ATTACHMENT C

**REVISED TECHNICAL SPECIFICATIONS
AND TECHNICAL SPECIFICATION BASES PAGES**

UFSAR CHANGE DFL 97011
SHORT-TERM/LONG-TERM CONTAINMENT PRESSURE AND TEMP

Figure 6.2-19a - Short Term Suppression Pool Temperature Response - Case 6a2 - 60% Mixing Efficiency

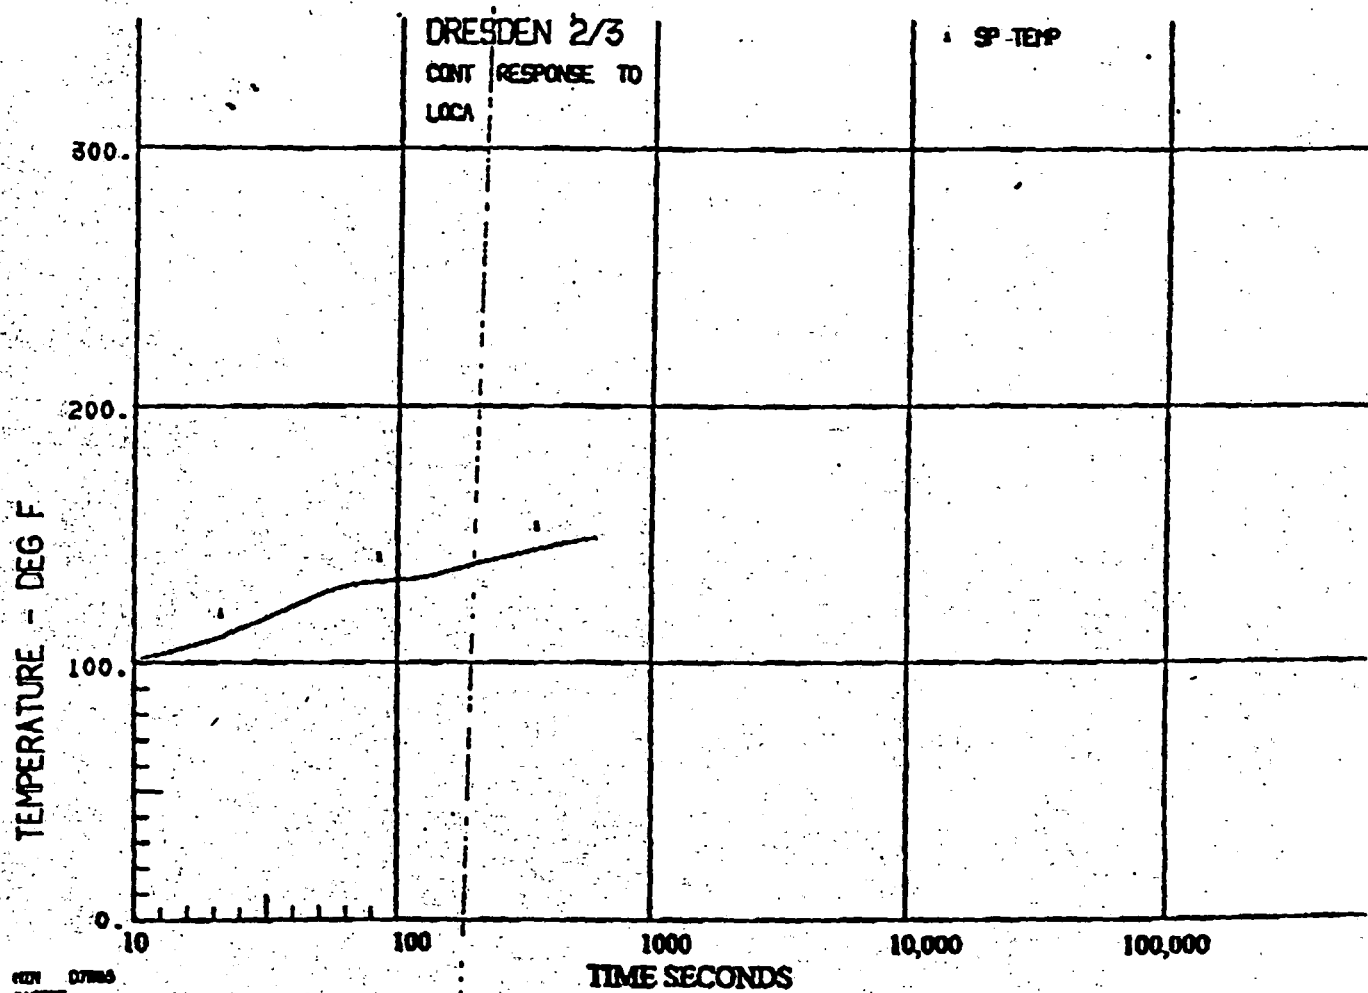
3	Table 6.2-19	N/A	N/A	Initiated Tables 6.2-19a and 6.2-19b to reflect the new suppression pool temperature and suppression chamber pressure responses evaluated for the containment short term response to a design bases accident (DBA) LOCA for minimum NPSH available. The discussion covers the worse case condition for the first 600 seconds of the accident. This change is a result of the Licensing Amendment to reevaluate LPCI and Core Spray pump requirements.
3	Table 6.2-20	N/A	N/A	Initiated Tables 6.2-20a, 6.2-20b, 6.2-20c and 6.2-20d to reflect the new suppression pool temperature and suppression chamber pressure responses evaluated for the containment long term response to a design bases accident (DBA) LOCA for minimum NPSH available. The discussion covers the worse case condition after 600 seconds into the accident. This change is a result of the Licensing Amendment to reevaluate LPCI and Core Spray pump requirements.

ADD FIG. 6.2-19a & -19b From attached insert

Figure 6.2-20a - Long Term Suppression Pool Temperature Response. Case 2a1 - High (100%) Mixing Efficiency

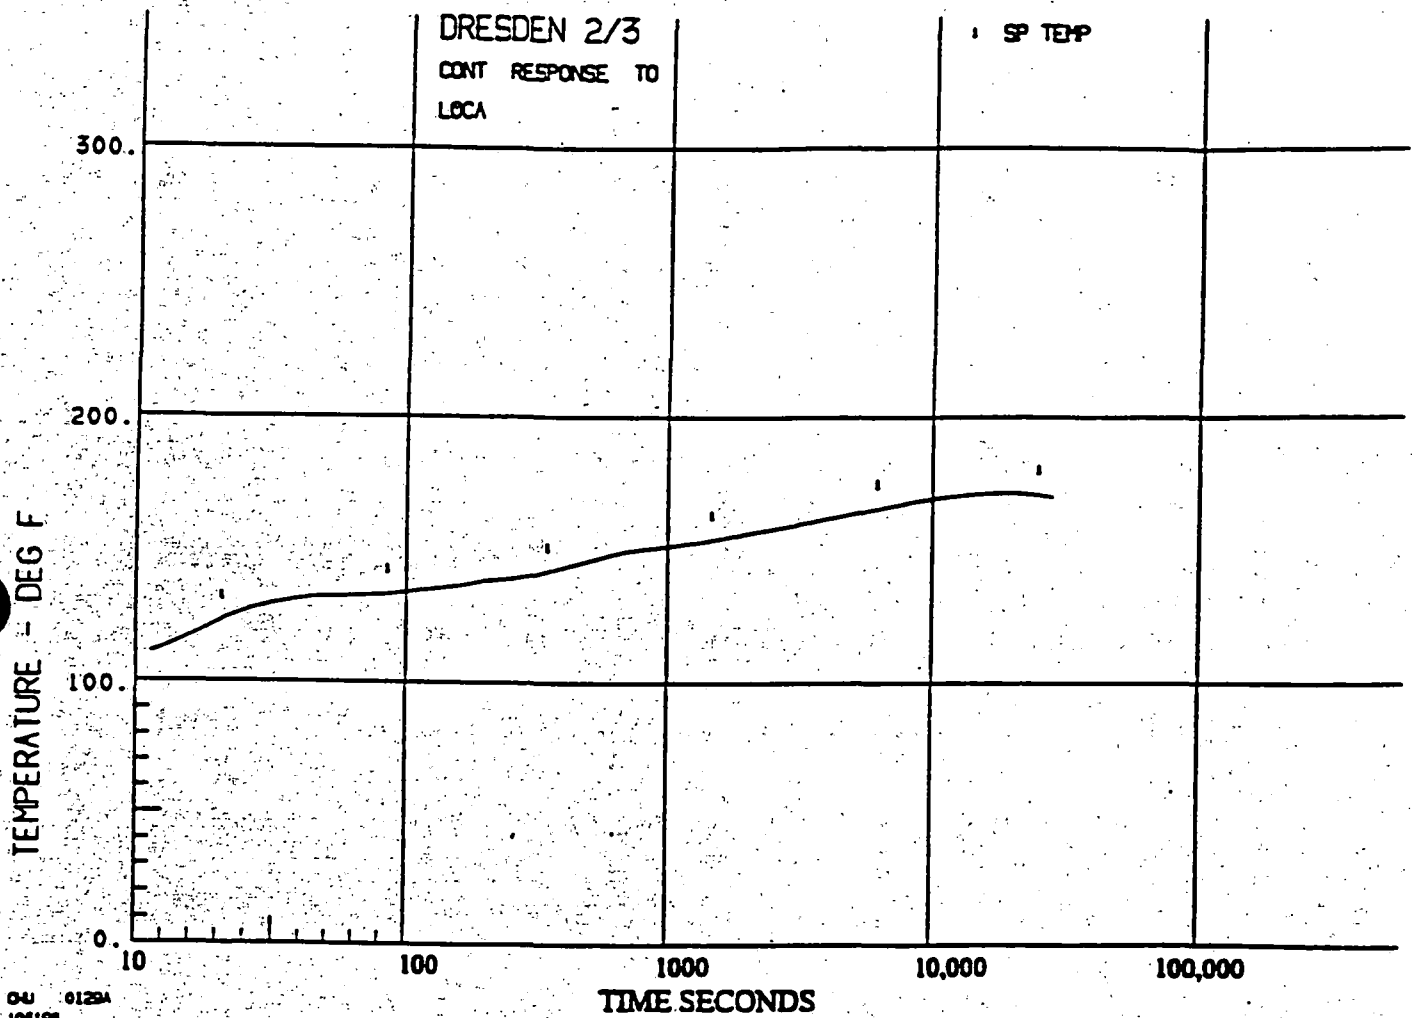
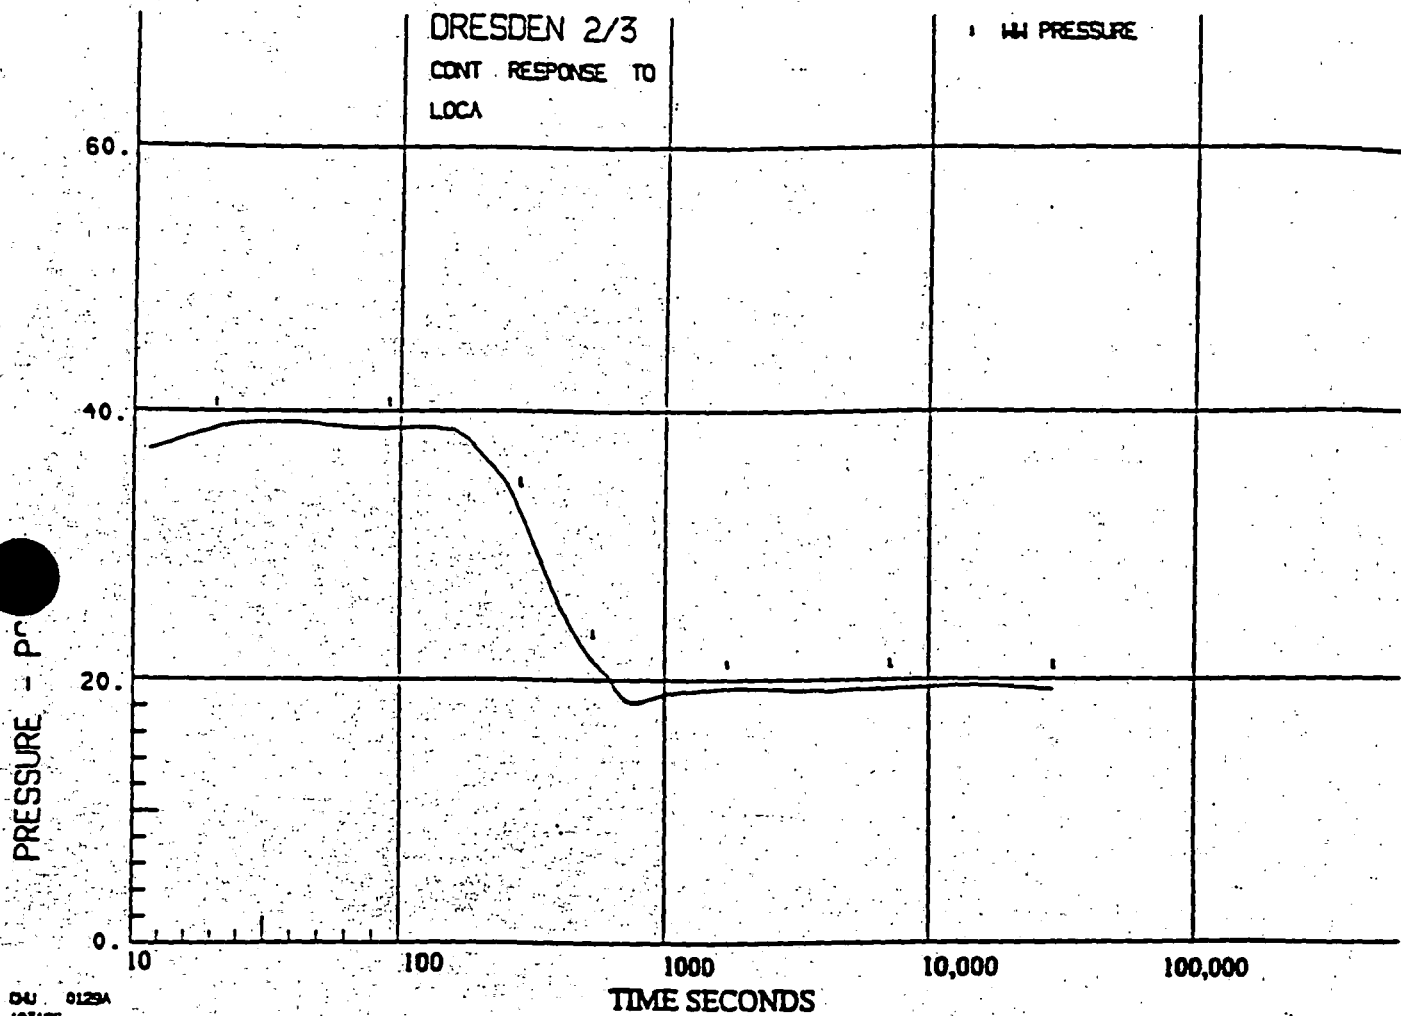
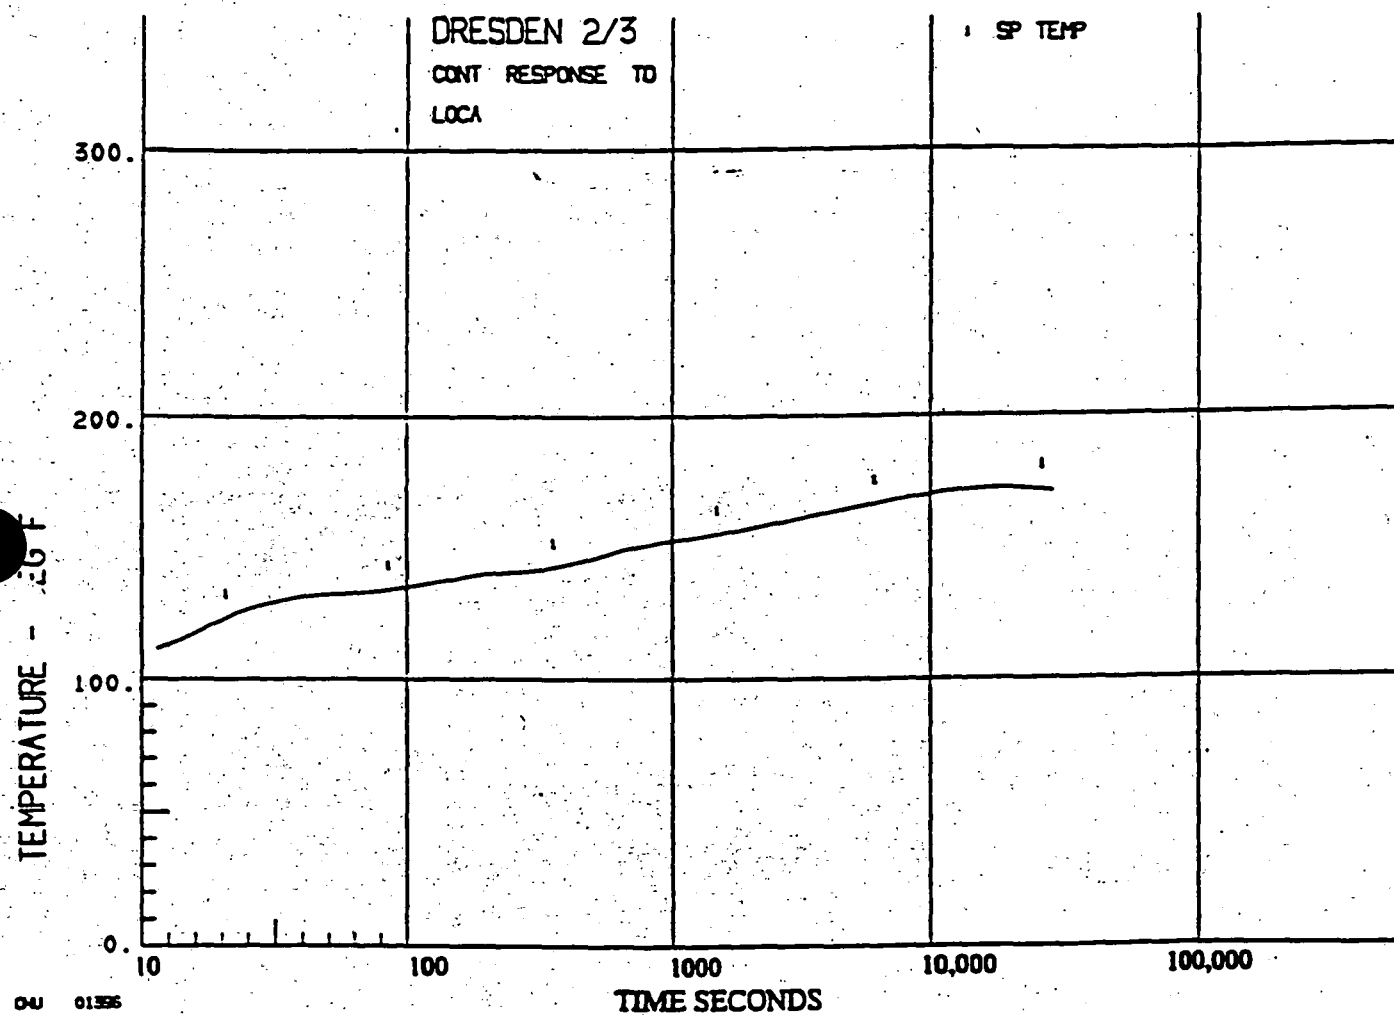
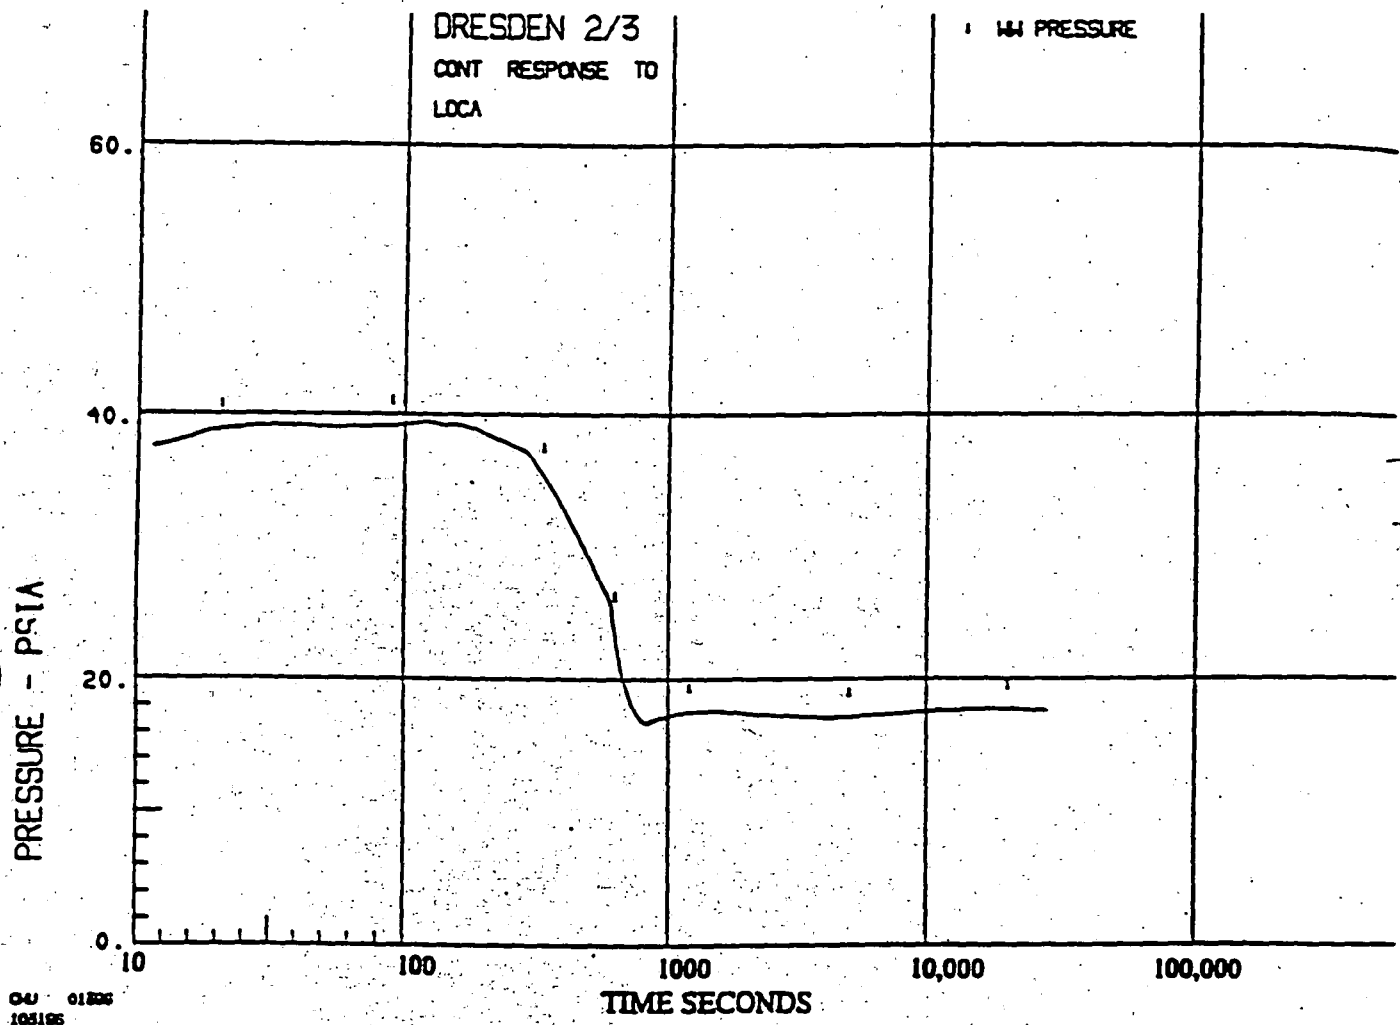
ADD FIG. 6.2-20a, 20b, 20c, 20d From attached insert
6-v

FIGURE 6.3-80

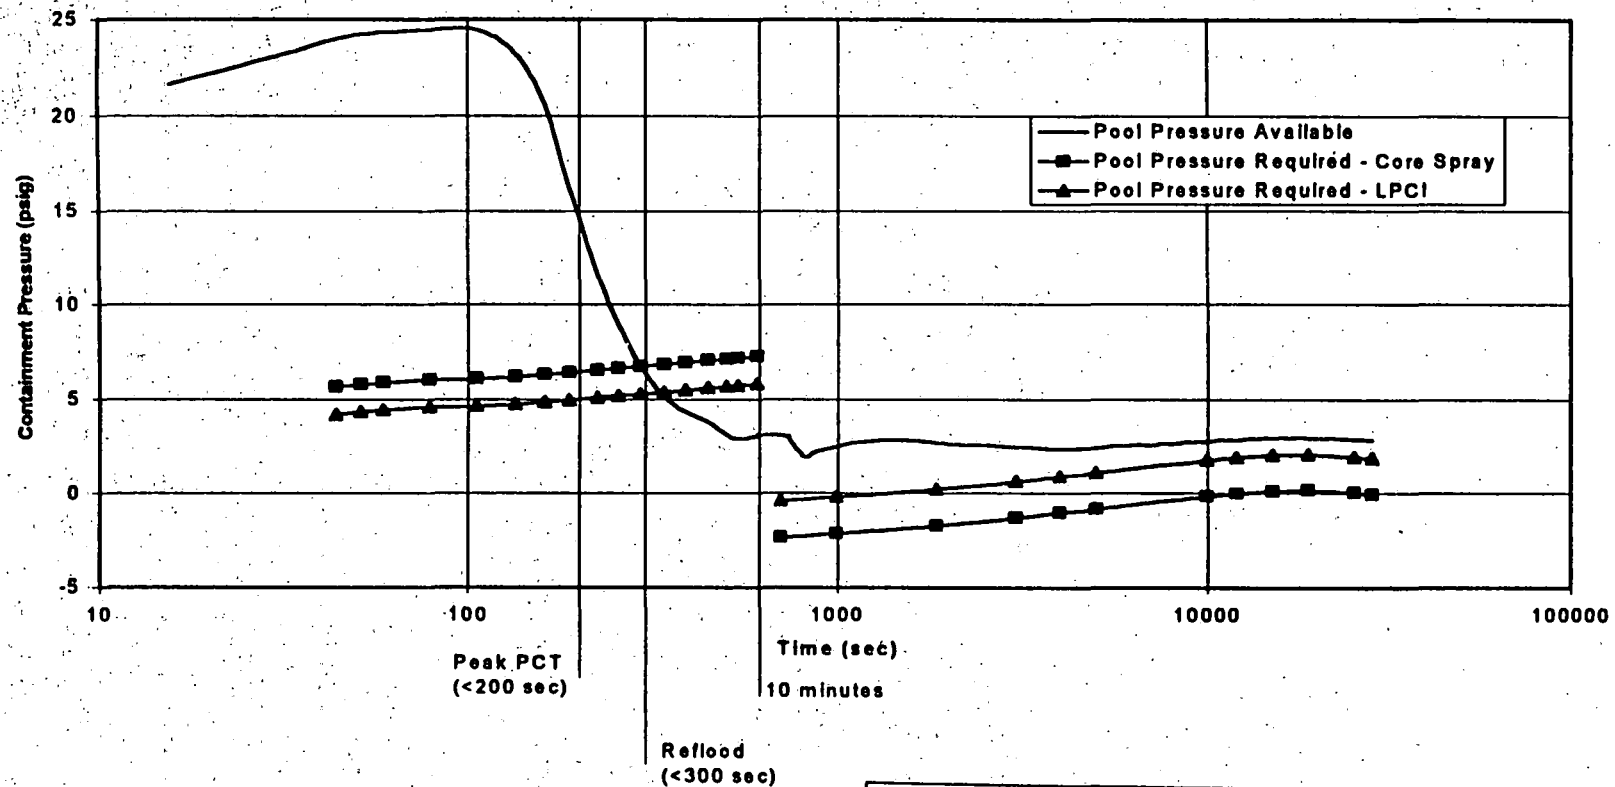
Figure 6.3-80 gives a graphical representation of the minimum required containment pressure to meet NPSH requirements for both LPCI and Core Spray pumps. The chart covers both the short-term (≤ 600 seconds) and long-term (> 600 seconds) periods.

REPLACE W/
NEW FIGURE
6.3-80

FIGURE 6.3-83

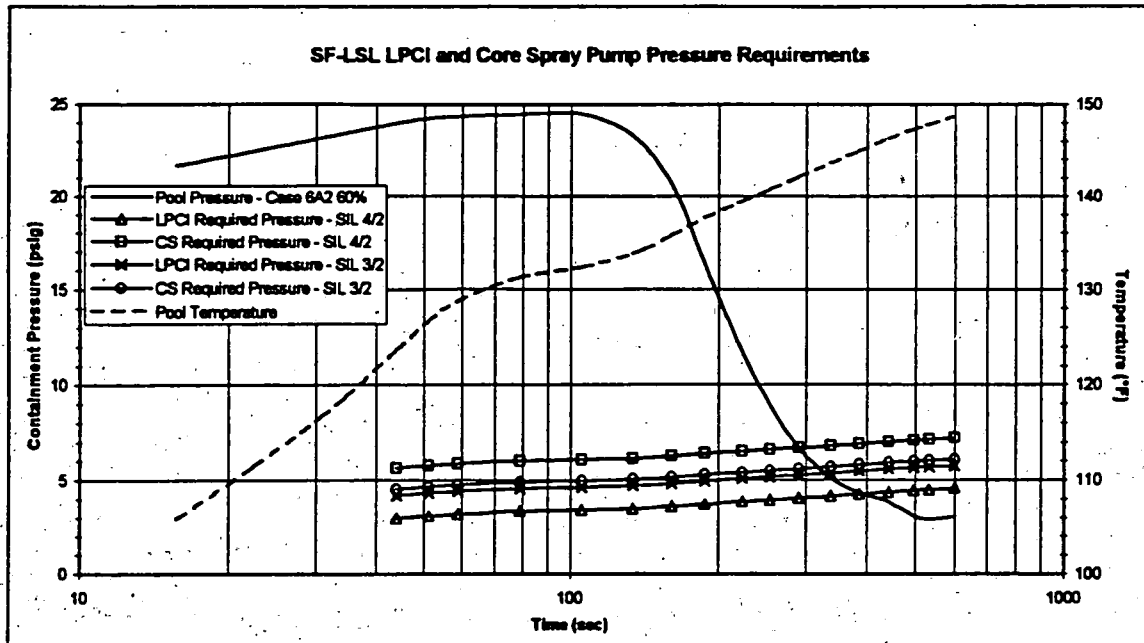
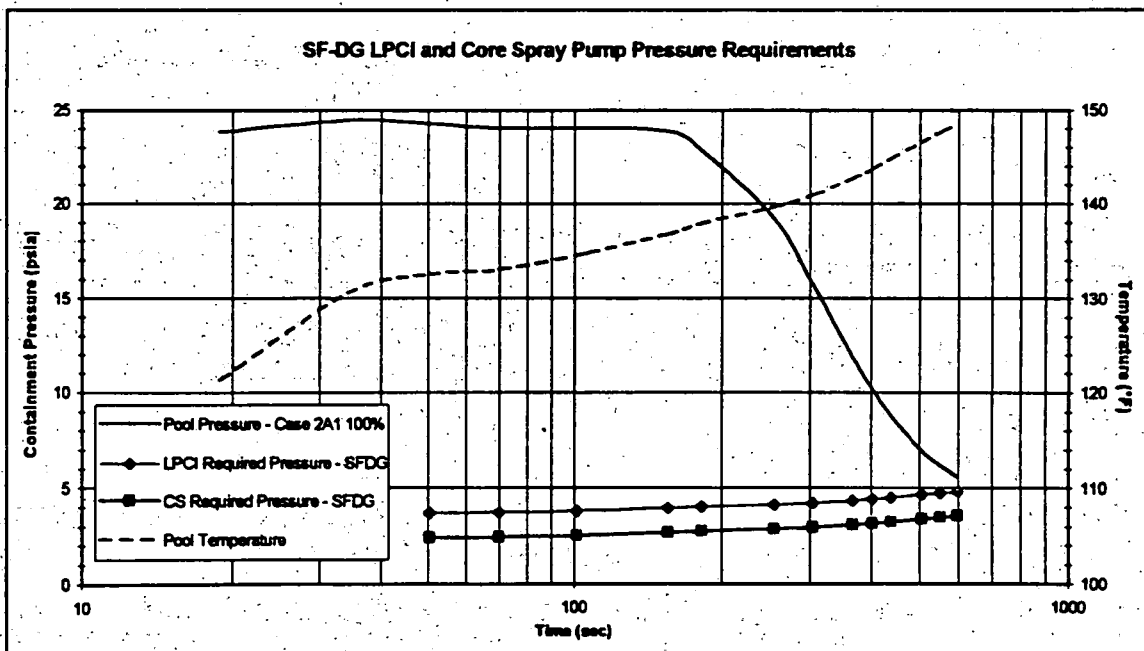
4	Figure 6.3-83	N/A	N/A	Initiated a new figure reflecting the current design information.
4	Figure 6.3-89	N/A	N/A	Initiated a new figure reflecting the current design information.
5	9.2.1.3	4	9.2.2	Added design information that identifies the operation and location of the differential pressure control valve for the LPCI heat exchanger and the minimum CCSW flow of 5000 gpm for containment cooling. A change issued under DFL96140 identifying a different flow rate is being deleted by this change. This change is a result of the Licensing Amendment to reevaluate LPCI and Core Spray pump requirements.
5	Table 9.2-1	N/A	N/A	A change to the table initiated under DFL 96140 identifying a flow rate of 5600 gpm is being deleted. The table should only reflect containment cooling service water equipment specifications. This change is a result of the Licensing Amendment to reevaluate LPCI and Core Spray pump requirements.
